SERVICE BULLETIN

600.027

TO: Bloomfield Authorized Service Agencies
FROM: Allen K. Fransden
SUBJECT: SS-2 Satellite Brewer Control Board Upgrade

Applicable to: SS-2 Satellite Brewer Models 900023 and 900027

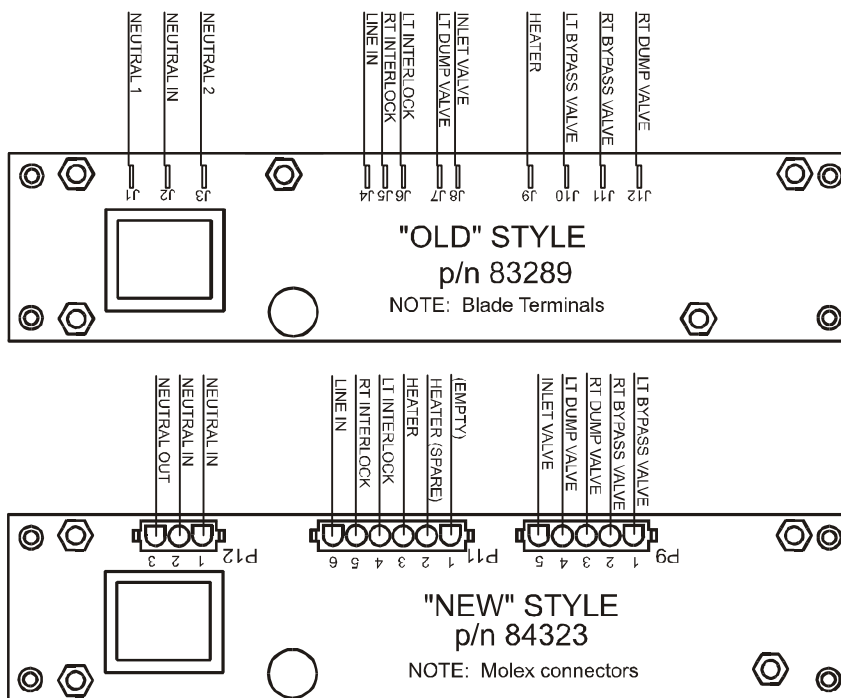
The CONTROL CIRCUIT BOARD has been upgraded. The "new" control board is p/n 84323. The "old" control board (p/n 83289) is obsolete, effective immediately.

IMPORTANT: There is the possibility that undocumented upgrades have been made. In order to positively identify which board is installed, use the drawings below :

An upgrade kit to convert "old" style board to "new" style is available as p/n 83960. This kit contains the upgraded control board, as well as the modified wiring and revised brackets necessary to insure a proper installation.

If replacement of an "old" style board is required, upgrade kit p/n 83960 must be used.
